Village of Johnson Creek

Plan Commission Report

August 21, 2014

To: Village of Johnson Creek
From: Michael A. Slavney, FAICP, Village Planner
Date: 23 July 2014
Re: Preliminary Review Comments on Top Leaf Site Plan (7/20/2014)

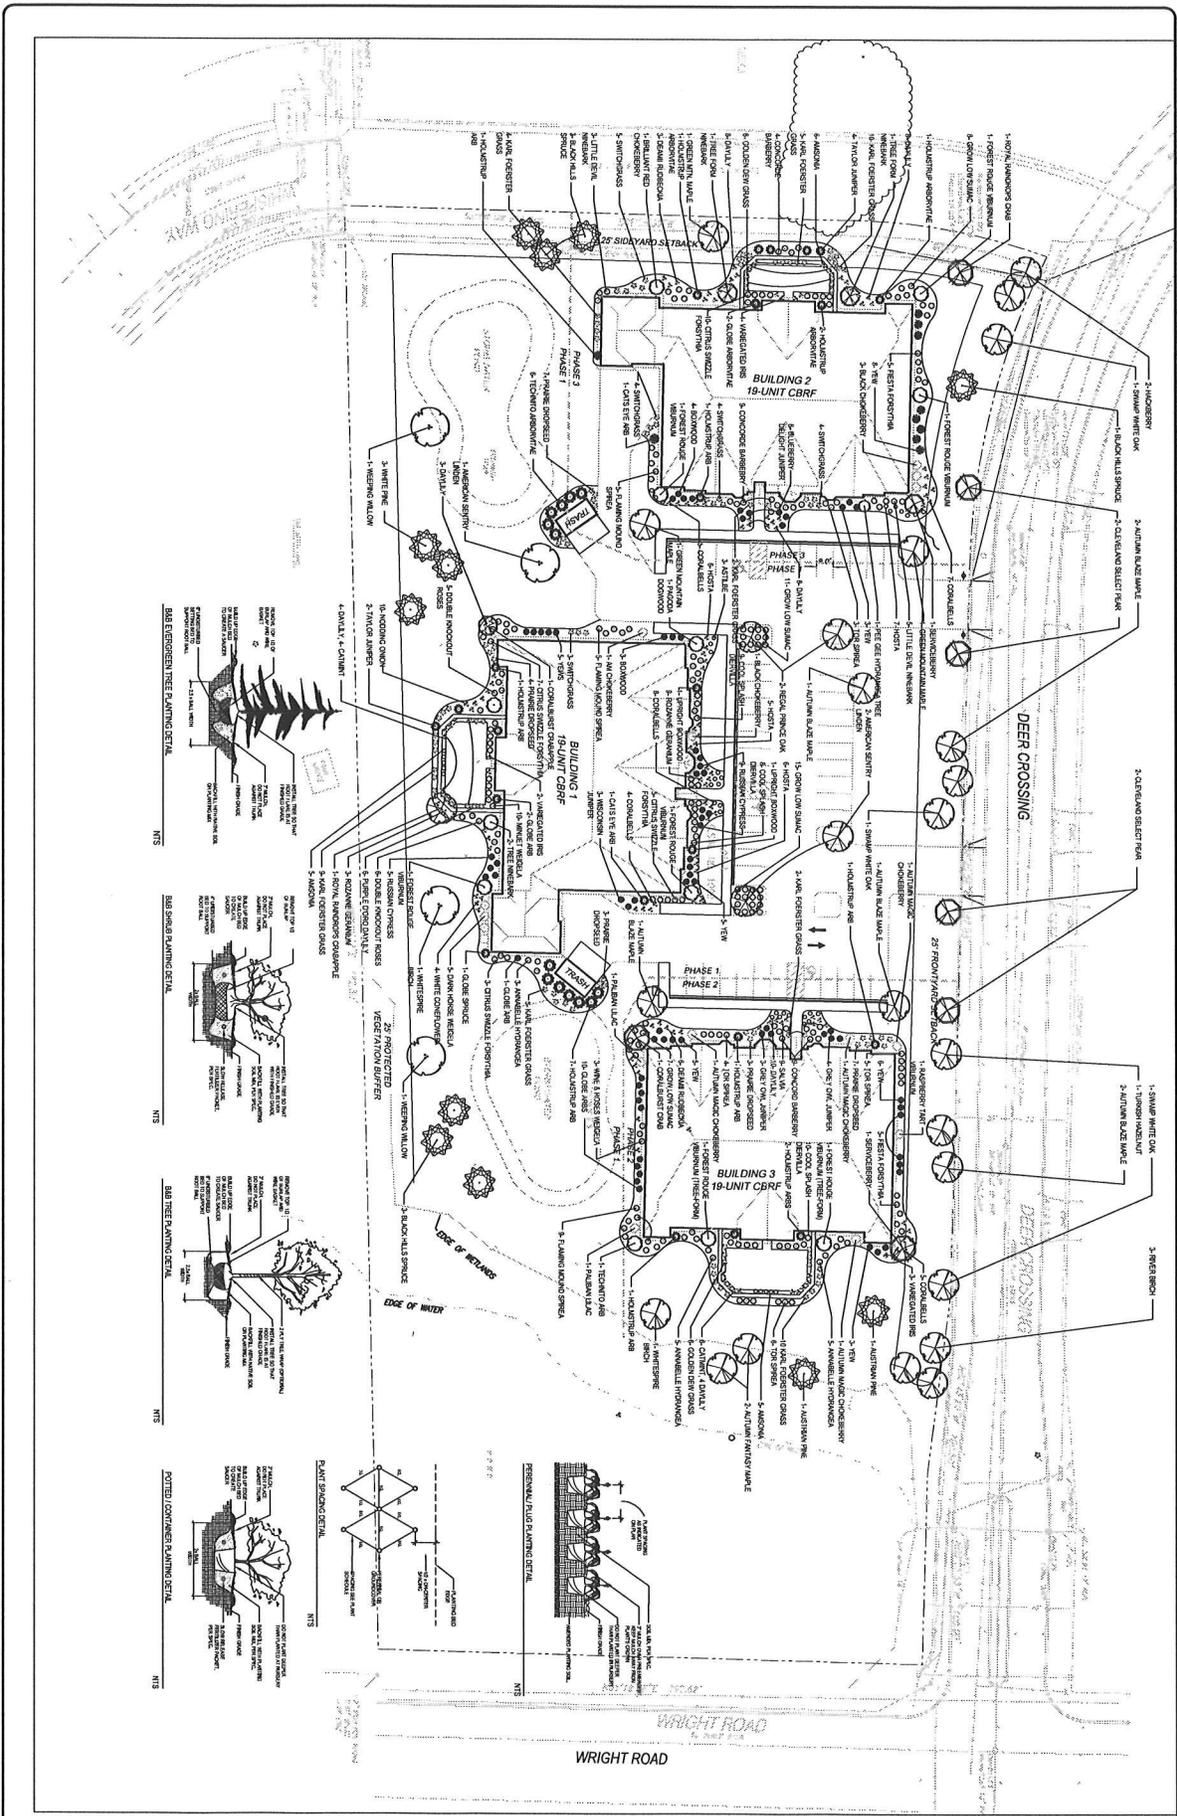
2. The dimensions depicted for the parking space and aisle do not match Village requirements, although the total area devoted is appropriate. These dimensions should be revised to show a minimum 26 foot wide driving aisle. Parking space depth can be reduced to 18.5 feet with the vehicle overhang that is provided.

3. The western driveway width should be provided with an "Entrance Only" and a "One Way Do Not Enter" signs. These locations should be shown on the Site Plan.

4. The sidewalk in front of the center building should be extended both east and west to the adjacent parking lots to provide a hardscape path between all three buildings. The appropriate ramping needs to be provided in these locations.

5. The southern 25 feet of wooded area on the south edge of the site should be labeled as "Protected Vegetation Bufferyard". If this area is not disturbed, then an additional landscaped bufferyard is required to be planted on the site, to transition to the single-family zoning to the south.

7. The site plan should depict a sidewalk connection from the right-of-way to the sidewalk in front of the buildings. I am comfortable delaying the installation of this connection until sidewalks are present on this portion of Deer Crossing.

8. A bike rack should be provided for the site as a whole, with a minimum of 4 spaces.
9. I have not yet seen a detailed landscaping plan or exterior lighting plan. I encourage the use of LED full cutoff fixtures for exterior lighting. If one or more light poles are needed, I encourage a maximum fixture mounting height of 14 feet, in addition to the required maximum 0.5 footcandle limit at the property line.

| SHEET NO. | T.2.0 |

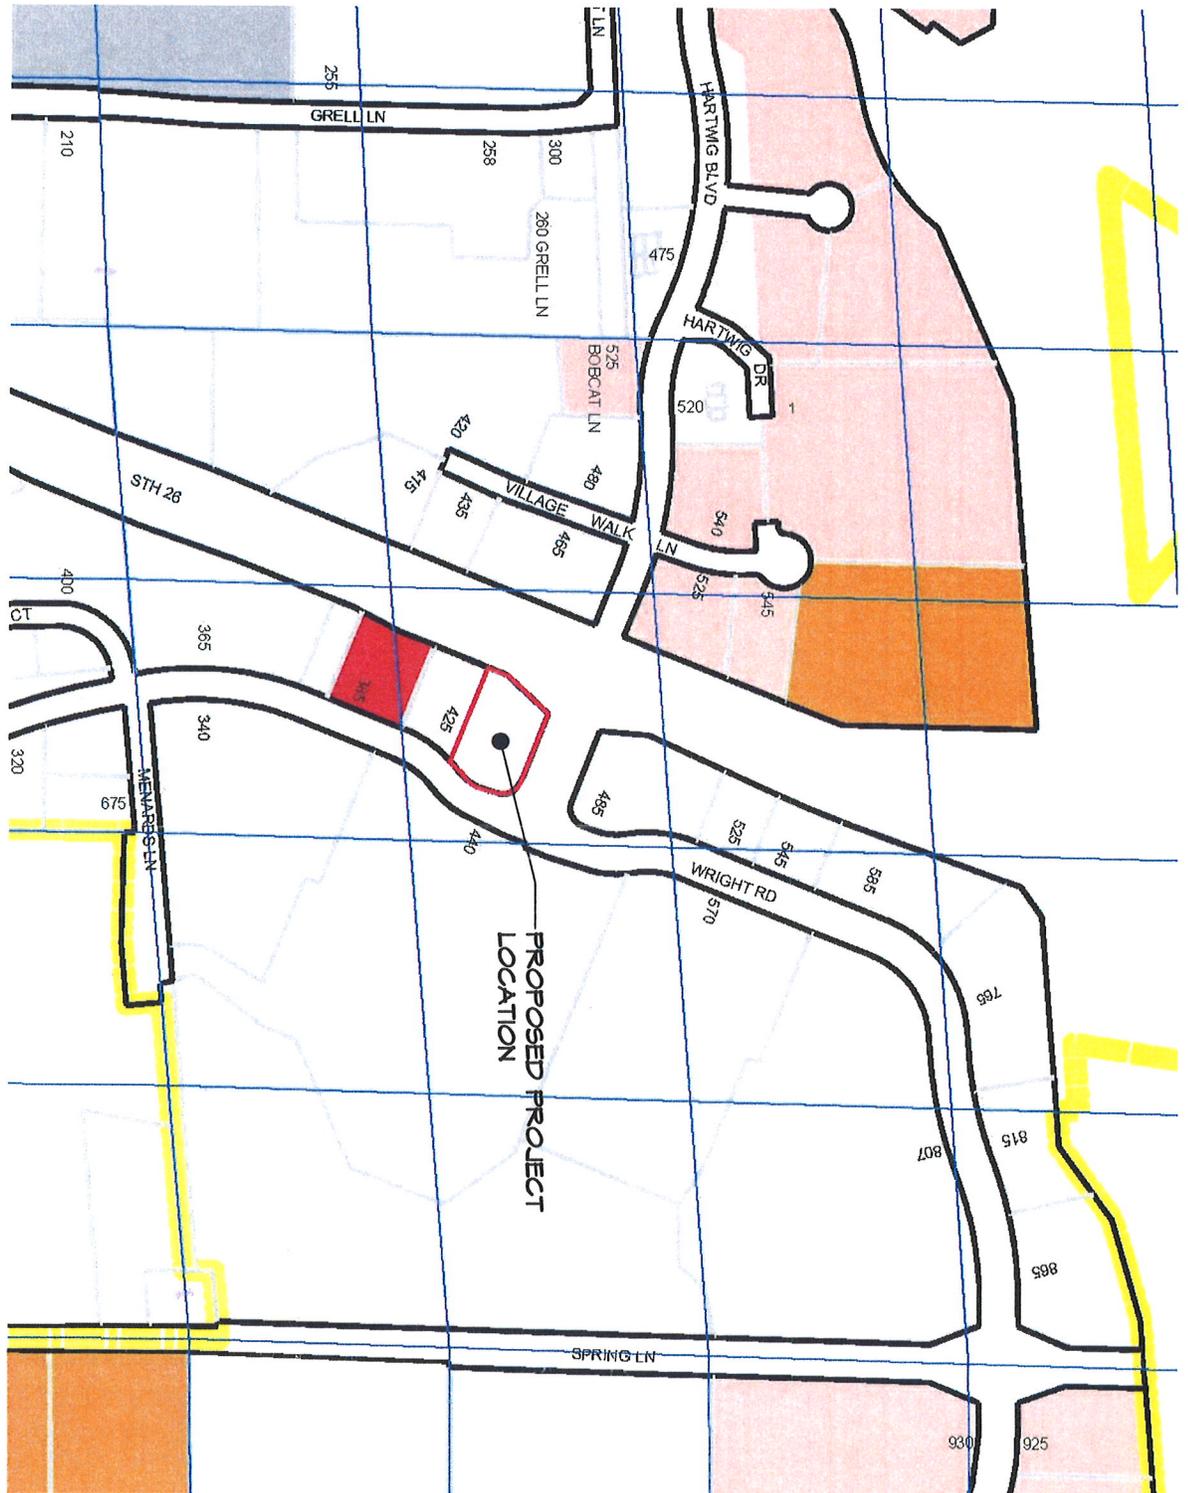
2. Site Plan Comments:

- a. Please provide a 24 foot wide drive connection to the south. The best place for this connection is the most southeasterly 2.5 parking spaces.
- b. Please provide a minimum 10 foot wide landscaped peninsula just west of the drive
- c. Please provide a minimum 10 foot wide landscaped peninsula just east of the trash enclosure. The combination of a-c, above will reduce the parking count by 3 spaces
- d. Please provide a bypass lane for the drive-through. The total width of the roadway should be 24 feet.
- e. Continue the sidewalk along the south side of the building to connect to the sidewalk on the west side of Wright Road. A striped crosswalk should be provided across the drive-through lane.
- f. Submit a revised Site Plan that complies with 2a – 2e. Re-work the site & storm calcs.

1 LANDSCAPE PLAN
1" = 20'-0"

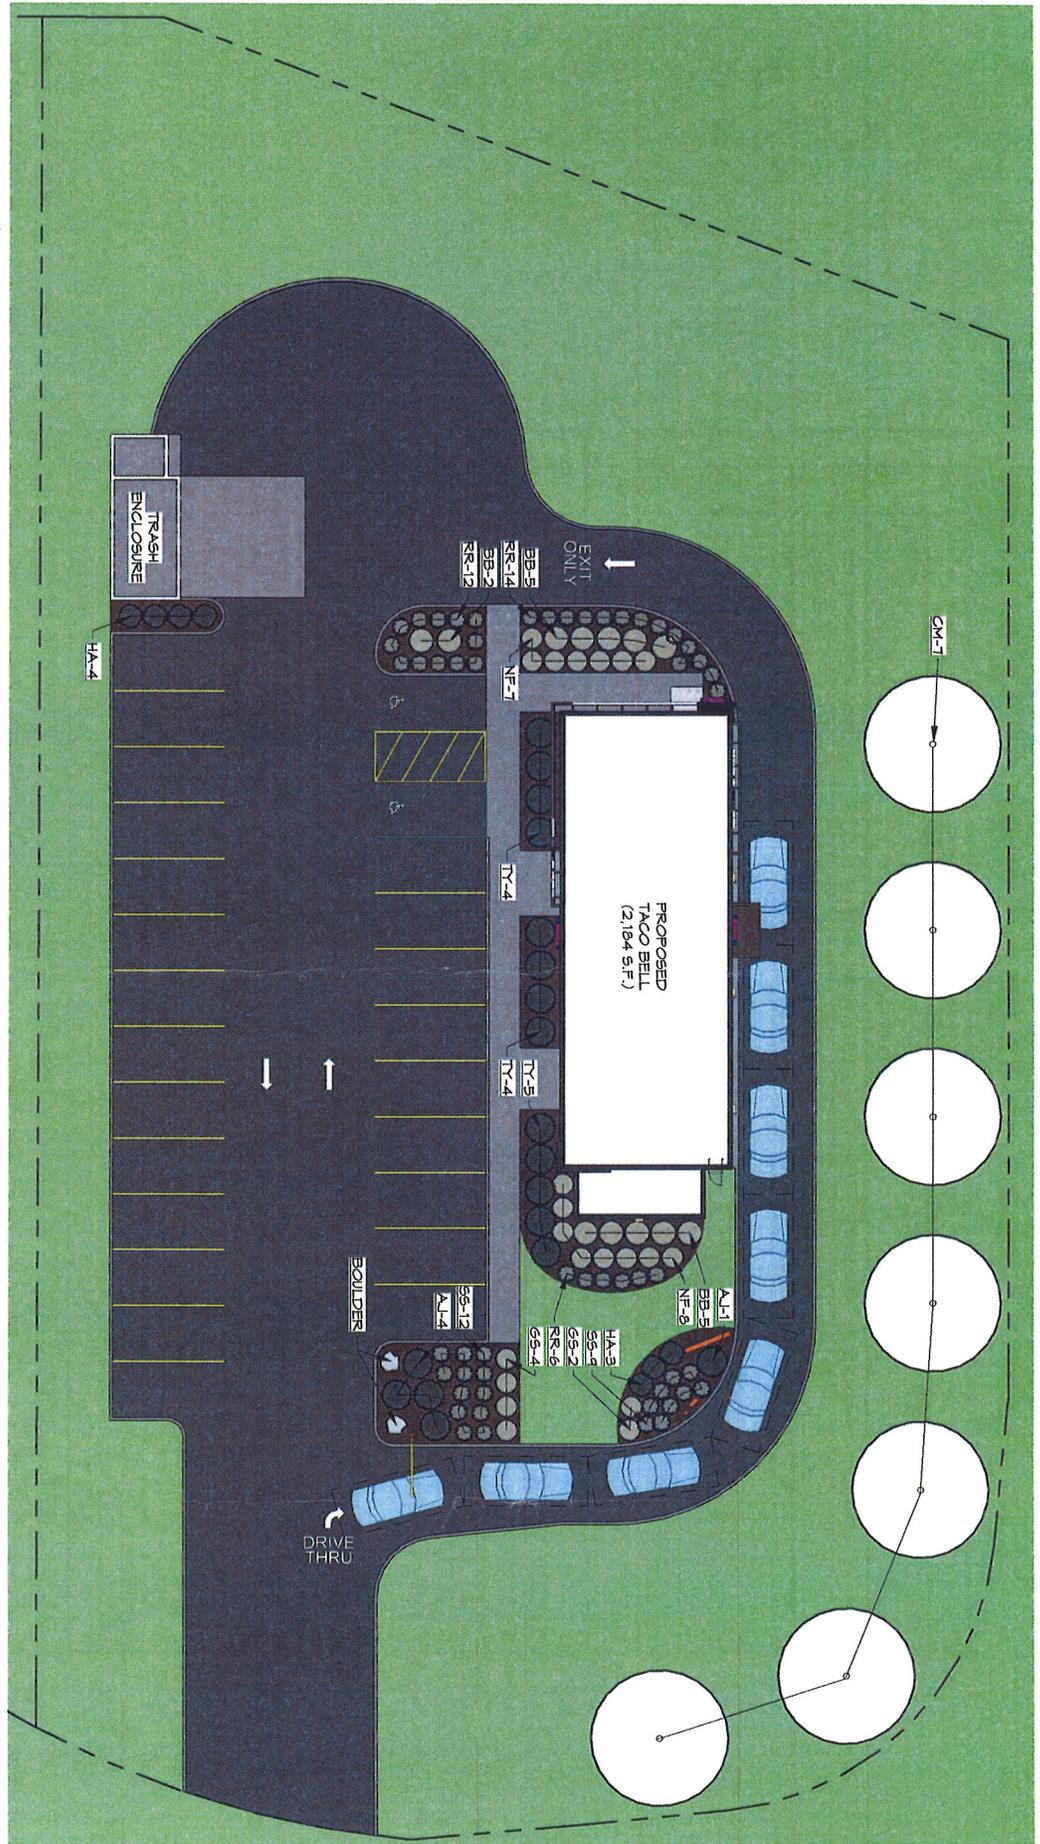
3. Landscape Plan Comments:

- a. The columnar Norway Maples are non-native and have an unacceptable narrow form
- b. Replace the Norway Maples with a minimum of two native species with a typical spreading form. Varietals are acceptable.
- c. Disperse these seven large trees around the site, with a minimum of one tree along Wis 26 frontage
- d. The calculation for the Developed-Lot landscaping requirement is missing, and thus, so are the required landscaping points. Please address this missing calculation and provide additional landscaping to meet the requirement. See Section 250-75 D. for this requirement.
- e. Submit a revised Landscape Plan that complies with 2f and 3a-d.

| SHEET NO. | A2 |

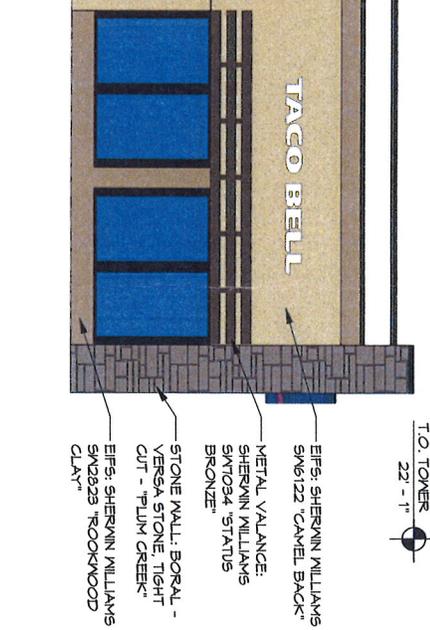
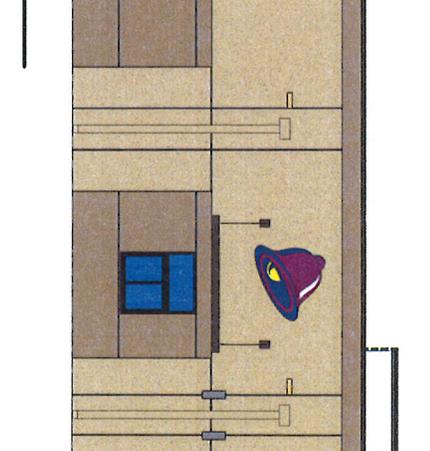
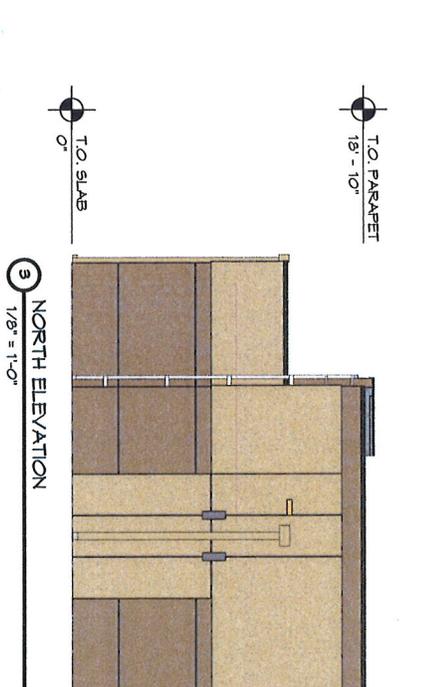
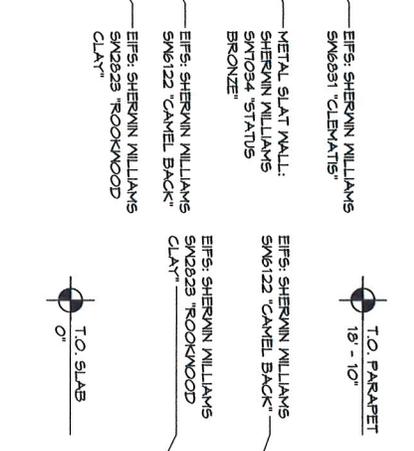
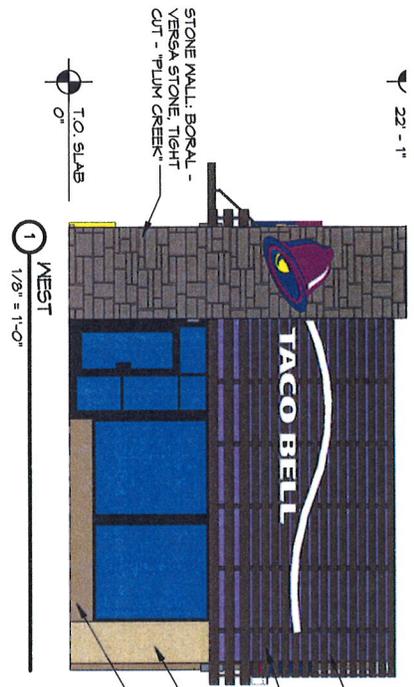
- a. Building elevations corresponding to the perspective drawings must be provided for all sides of the building and trash enclosure, noting proposed materials, textures and colors
- b. The building parapet should be at least as tall as the tallest rooftop mechanical or fixture. Please add a statement to this effect in the Narrative.
- c. I would consider the slatted purple back-lit fascia as a sign (part of the building that is specific to a particular business) in the same way Culver's typical standing seam metal roof was considered signage. Therefore, it would have to be figured-into the sign number and area calculations. The Zoning Administrator makes the final determination on this.

OVERALL GRADING
PLAN

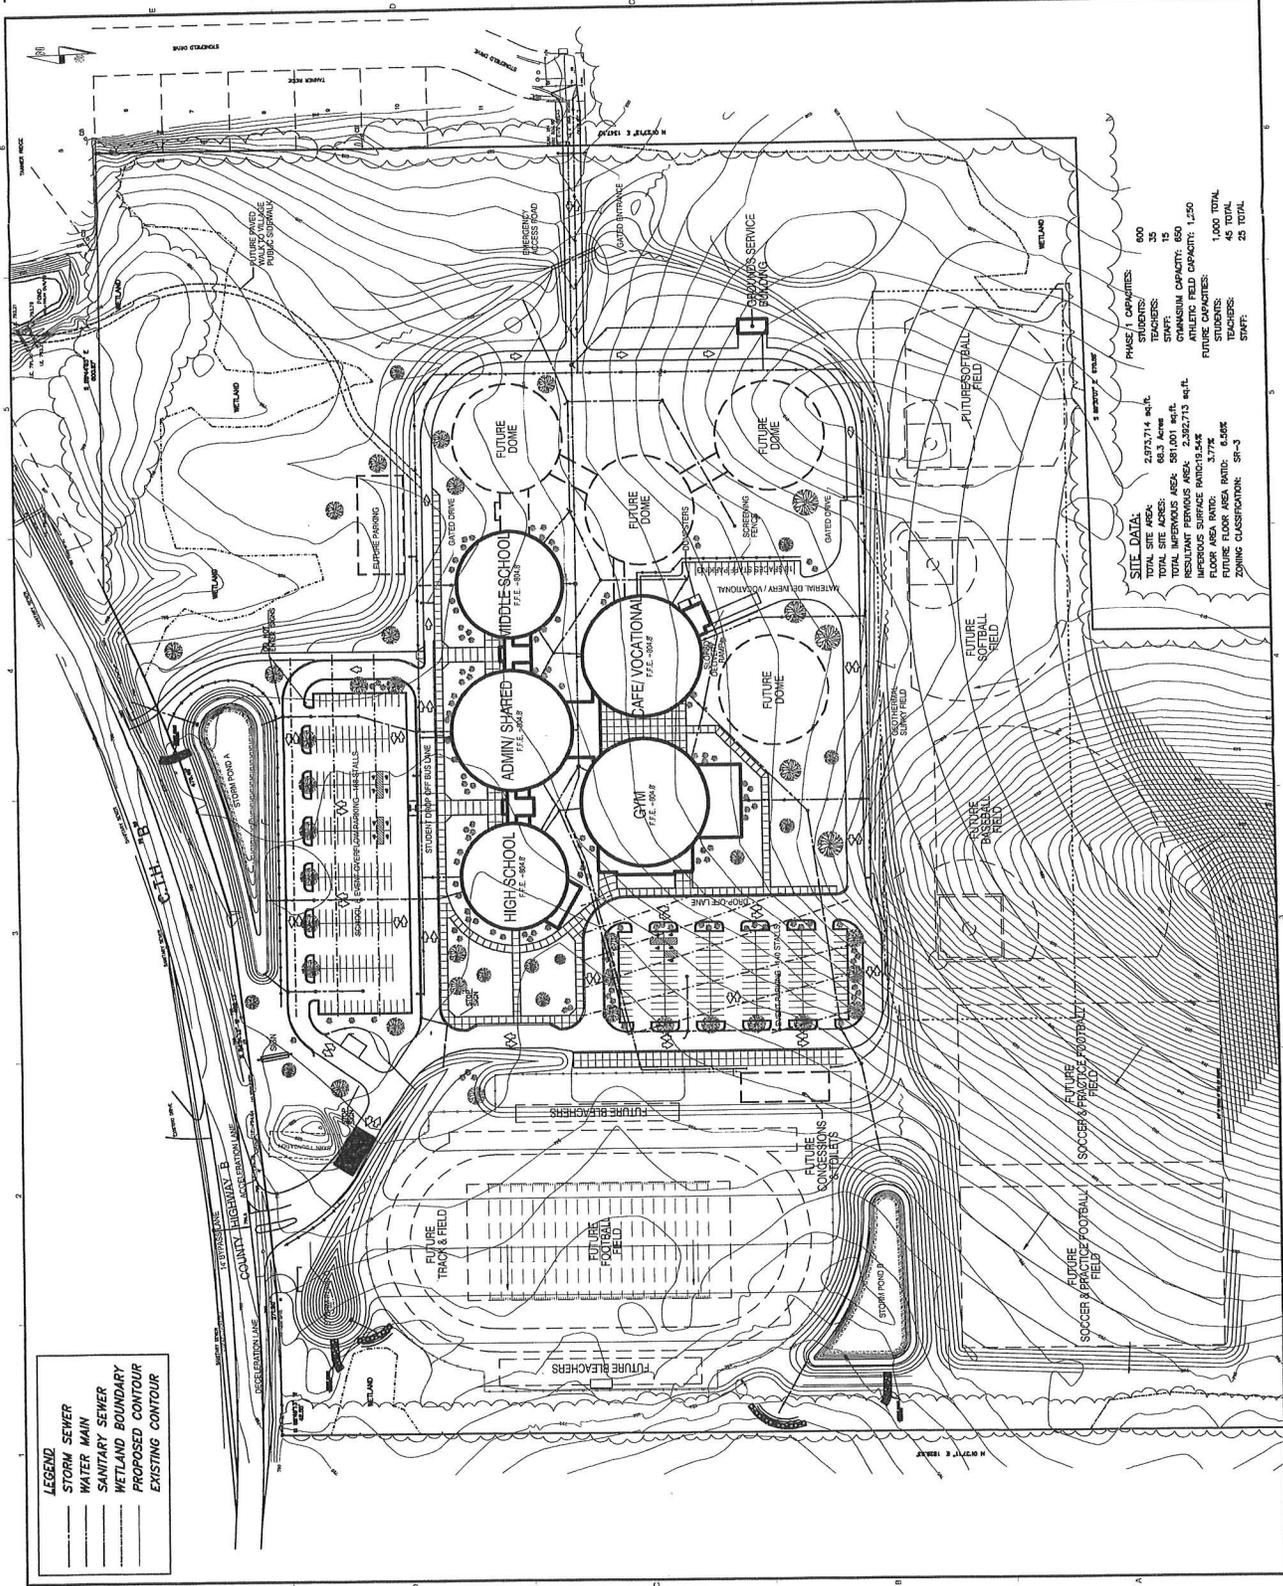
1. The proposed future grading for the football/track area should be reviewed. Currently there is over 4 feet of fall across the track from east to west. During the site development seems the appropriate time to fill the area for the future field. The stormwater ponds are necessary for the current development and will hinder access to the area in the future. A proposed plan of the final grades of the football/track area should be developed in order to verify the stormwater is still adequate and the site works within the property and wetland boundaries.
